Shalimar Place Subdivision

Statement of Issue: History of flooding in Barron Ct. cul-de-sac and rear of lot 24.

Town of Shalimar
Stormwater Analysis

GRADING AND DRAINAGE PLAN

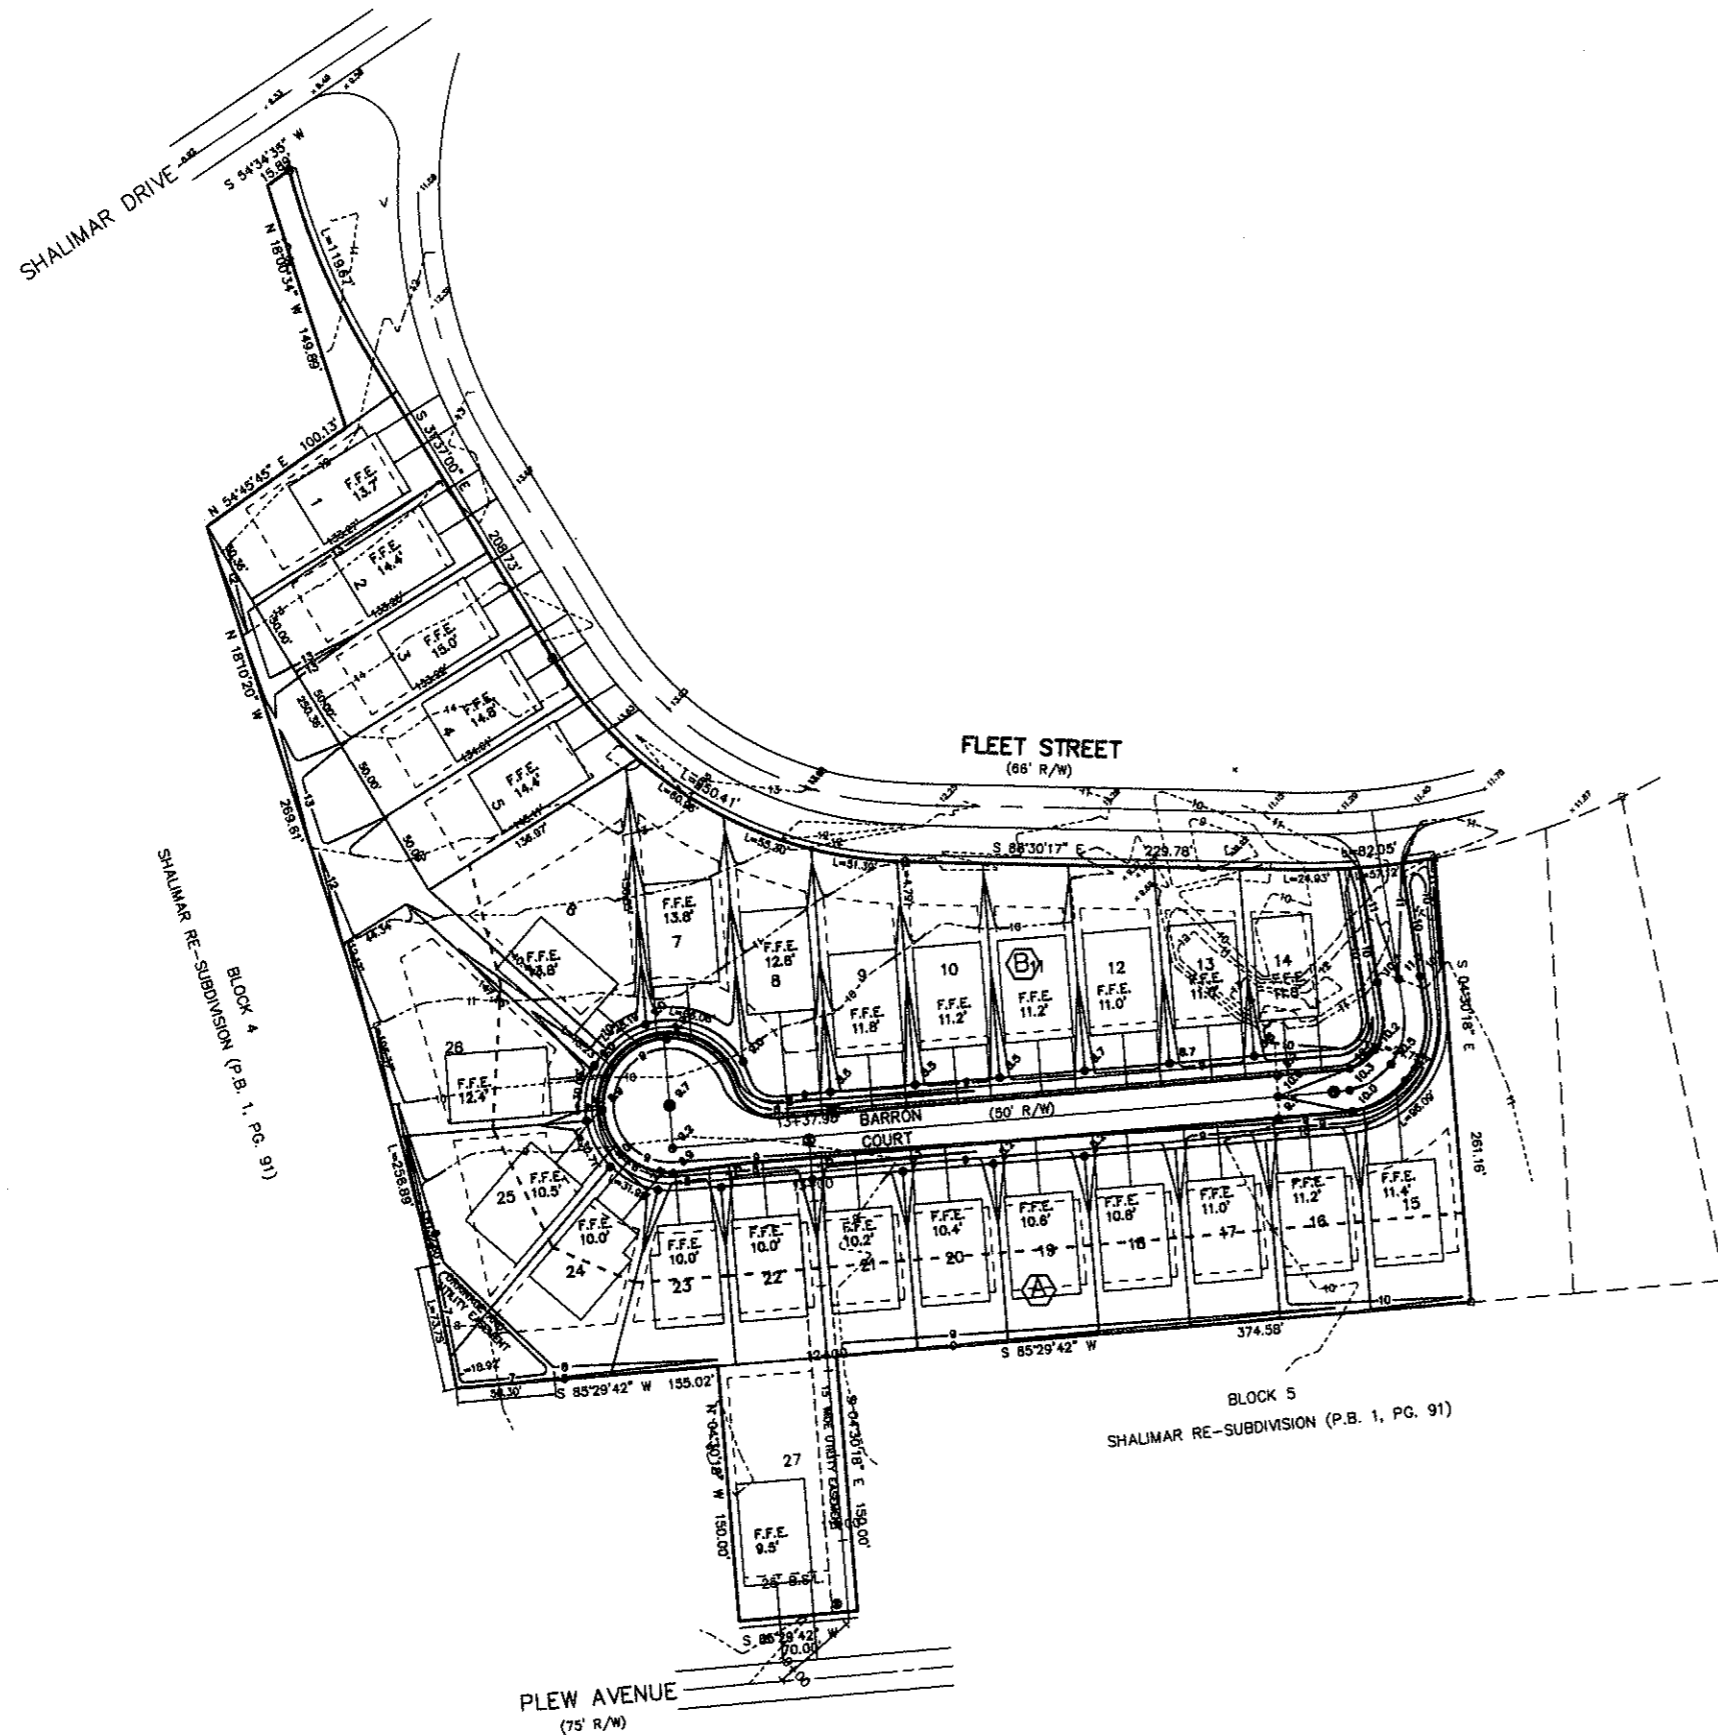
Results: A vertical datum was not identified on the original grading plan and not available from the original engineer. Our survey used NAVD 1988. There is a discrepancy between the surveys but it appears relative to the datum used. Generally, roads were installed in general compliance with the subdivision grading plan and the original datum. Side road swales are generally in existent but some have been filled. Swales between lots appear non-existent.

Impression: The original design delineated two storm drainage basins, identified as A and B on the plan. Once Basin B overfills its capacity, it discharges into Basin A between lots 24 and 25. Trees and landscaping impede this movement of stormwater. Once Basin A reaches its capacity, it floods Lot 24 until a depth is reached and stormwater can move in a southeasterly direction. However, that movement is greatly impeded by wooden privacy fencing, a generally rising terrain, and structures to the southeast. In other words, once Basin A is filled, additional flooding occurs in the rear of lot 24 due to no clearly defined outlet from the retention pond in the rear of lot 24 and the Subdivision.

Additional Observations: There does not appear to be any accounting within the grading plans for conveyance of runoff from upstream. The stormwater retention pond of the Shalimar Annex is immediately upstream of Shalimar Place Subdivision. Consequently, during extreme rainfall events, several in recent years, the Shalimar Annex pond fills and overtops its bank. Discharge from this pond is generally routed between lots 12 and 13 causing periodic flooding of porches and Florida Rooms for those residences. The stormwater is further conveyed to the cul-de-sac where it causes additional downstream flooding problems.

Recommendation: Authorize engineer to begin preliminary options for project(s) to mitigate flooding and prepare budget costs.

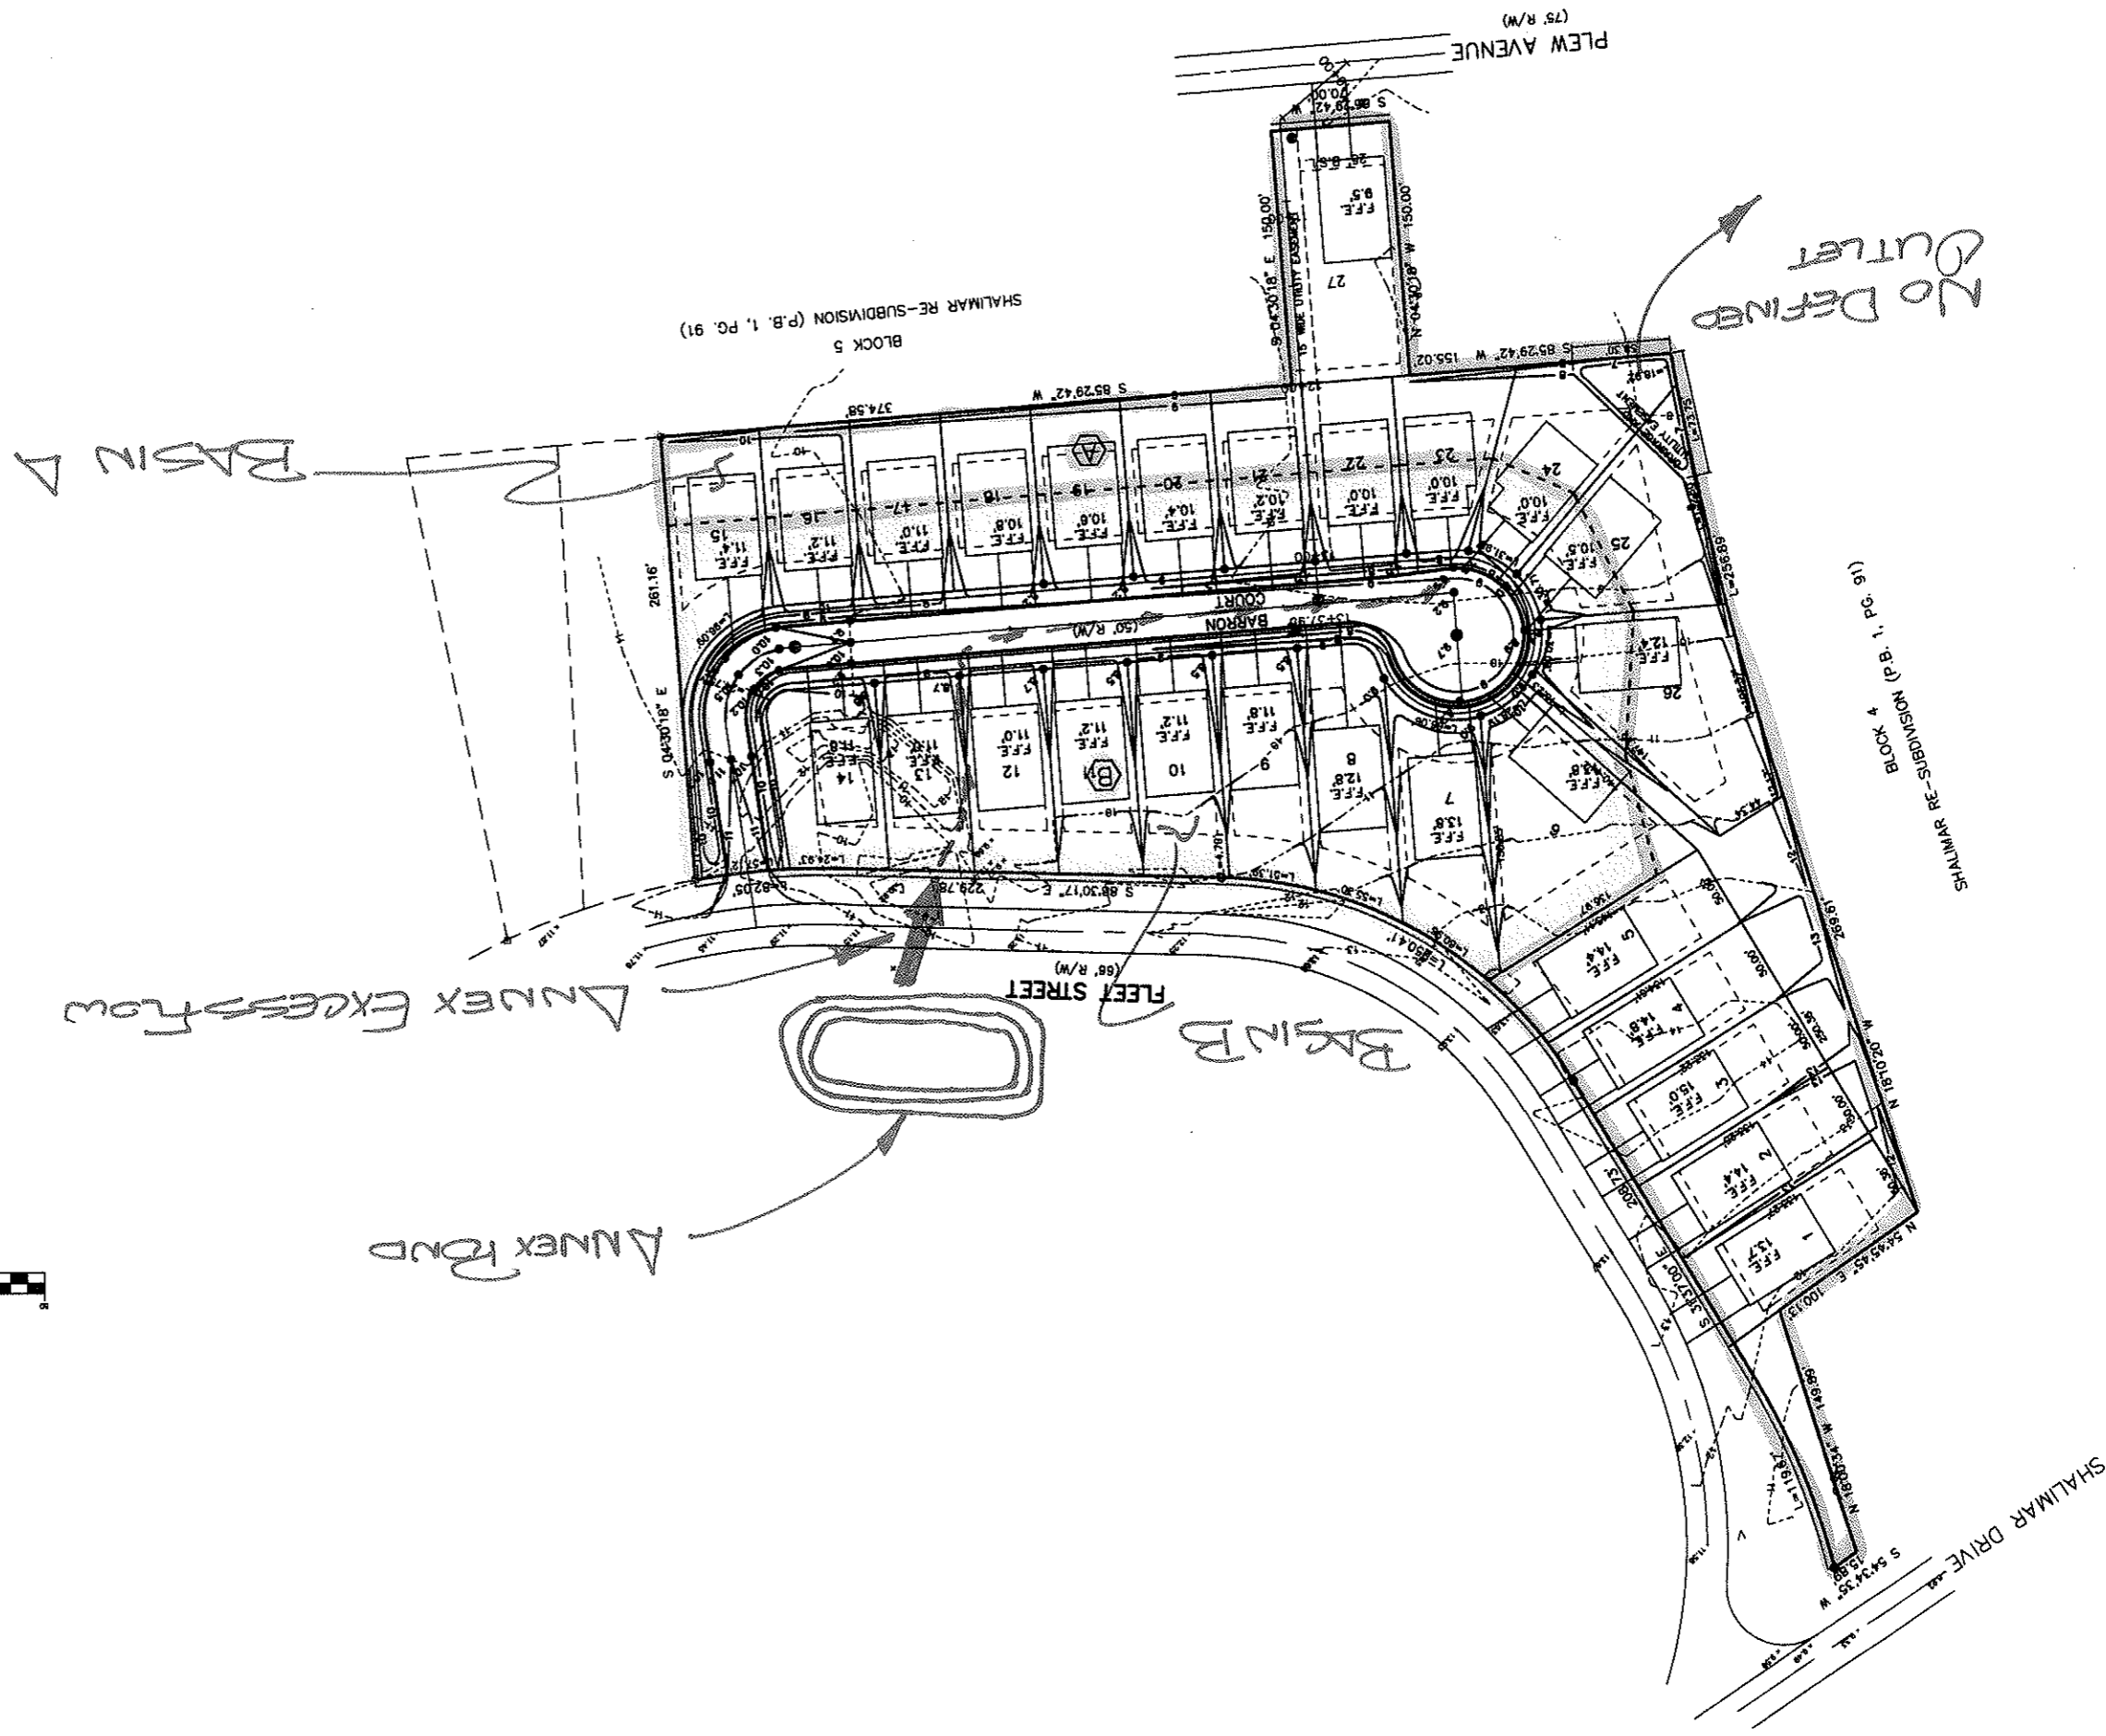
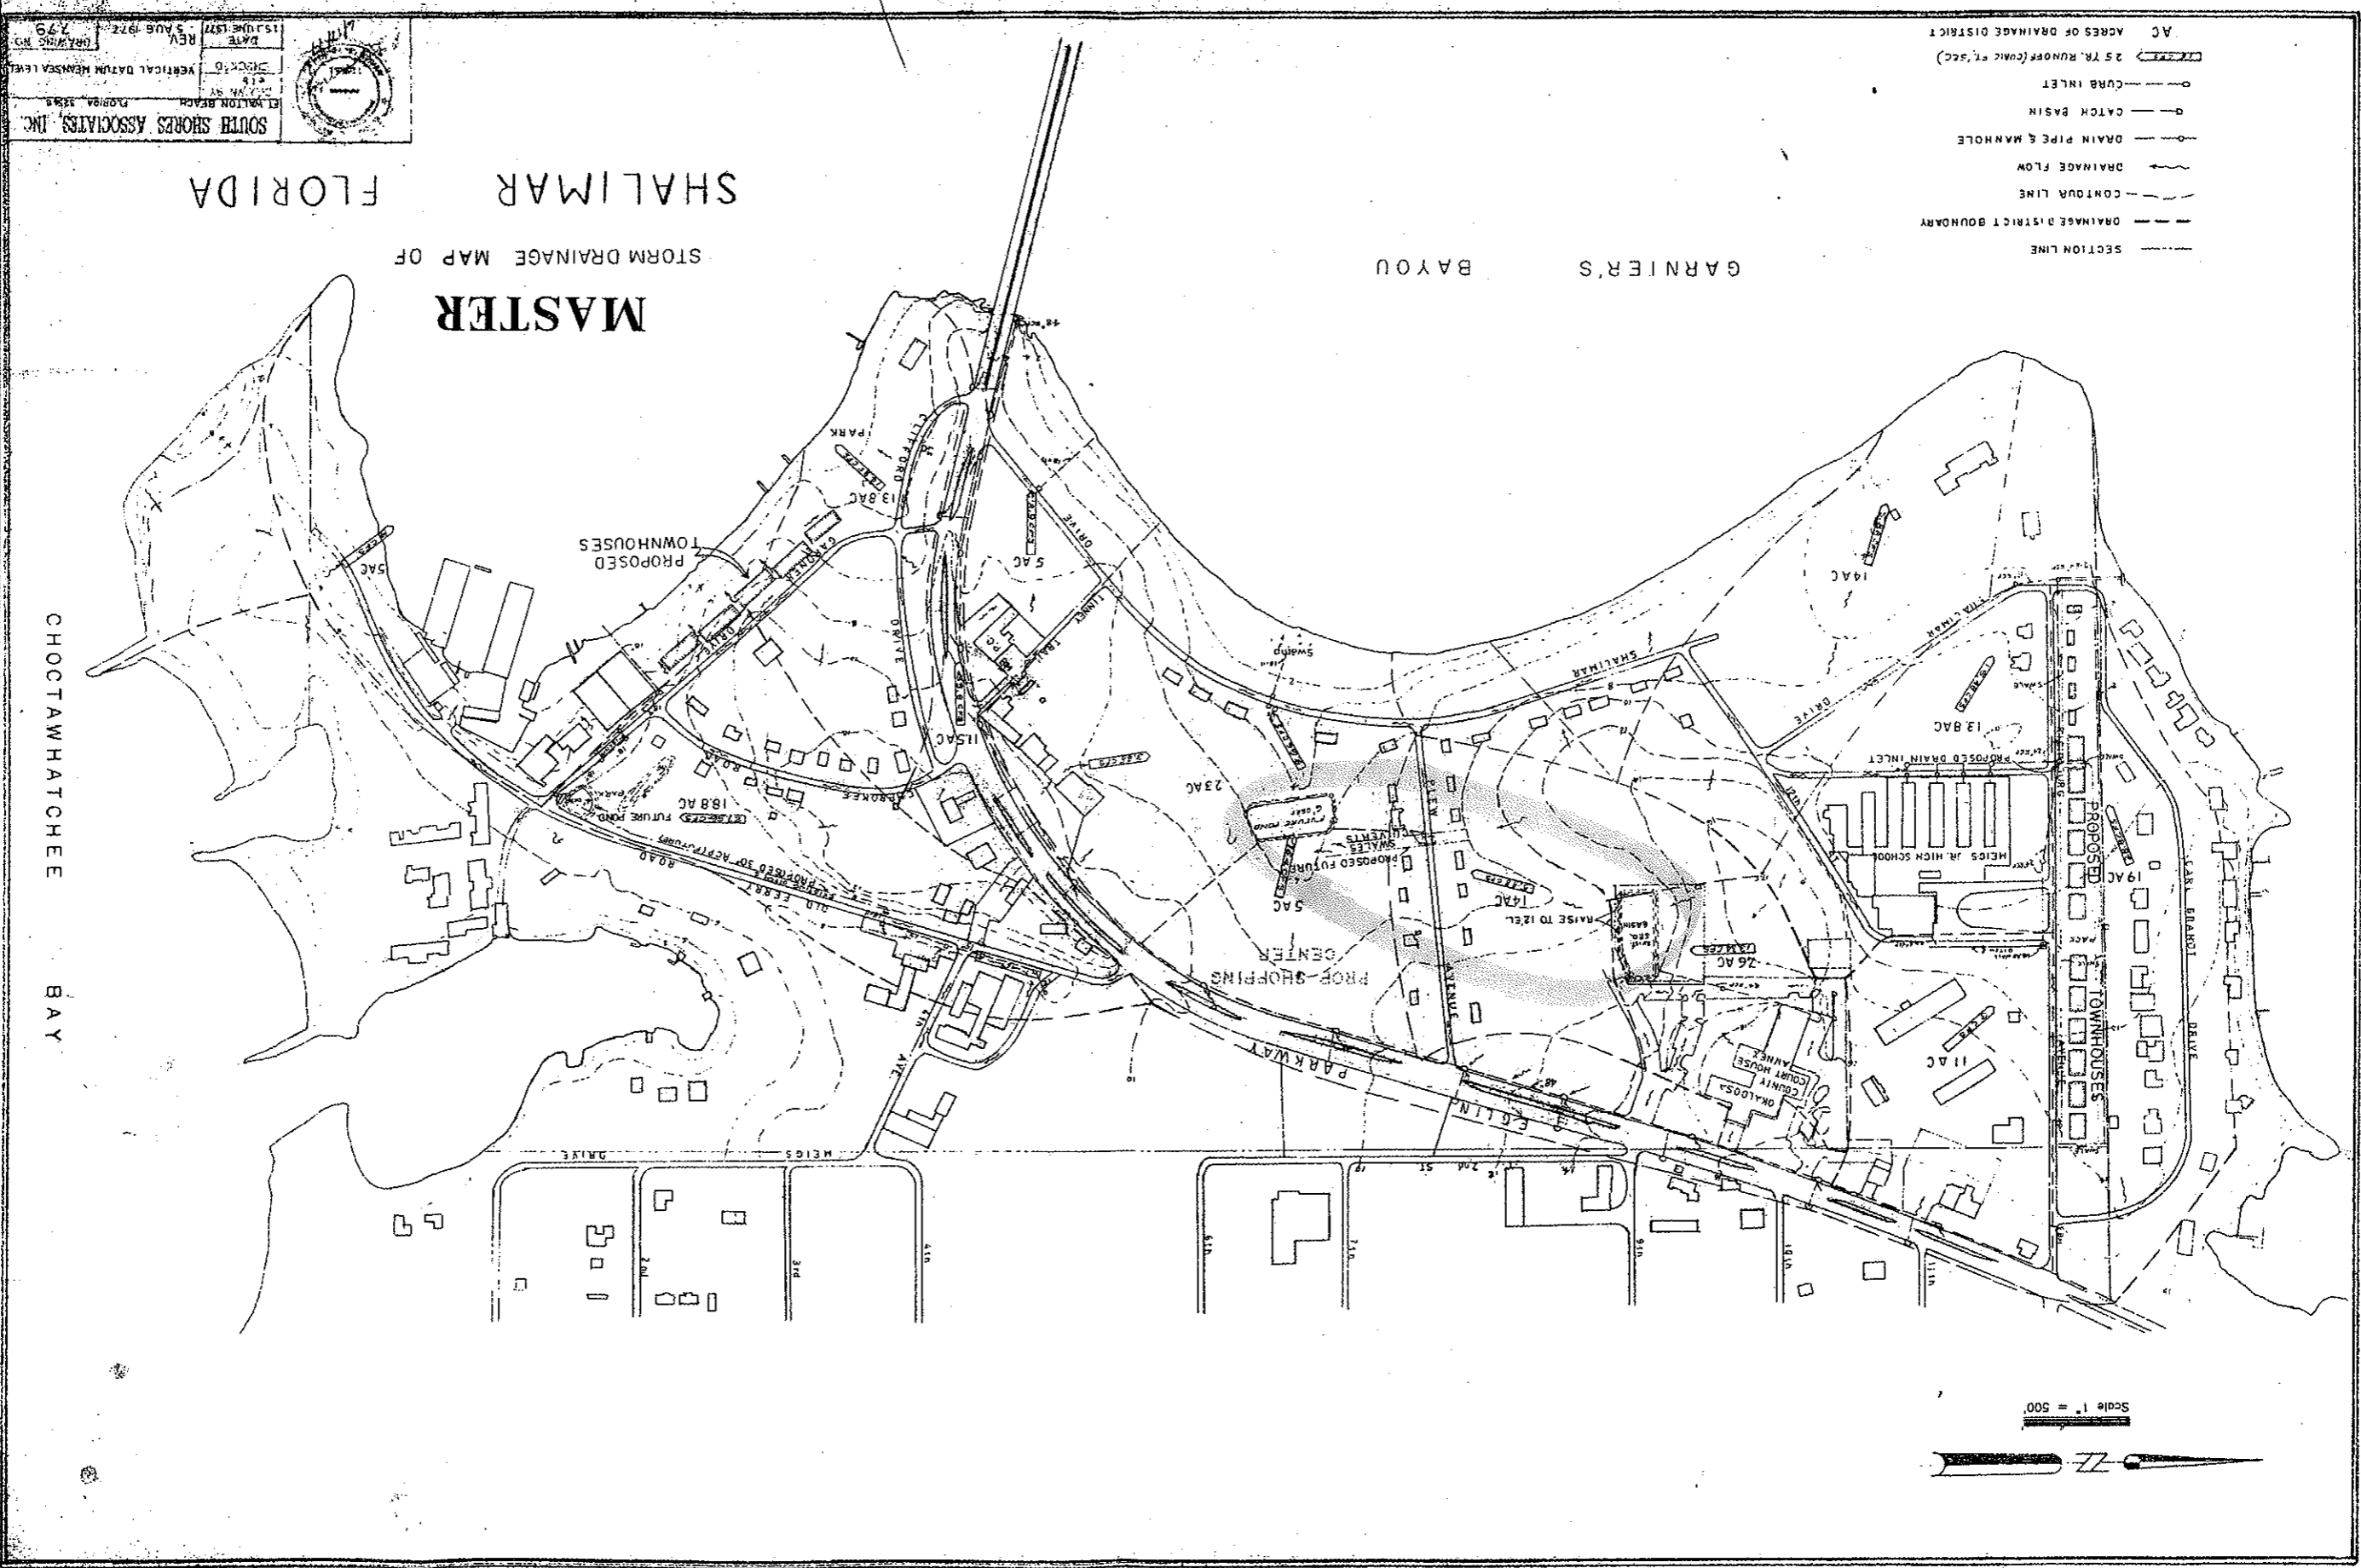
The Stormwater Master Plan of 1977 identified proposed future swales across Plew Avenue to address excess stormwater from the Shalimar Annex and the undeveloped area that would become Shalimar Place subdivision. There is no evidence to show that any improvements were made as part of Shalimar Place S/D to promote that drainage.
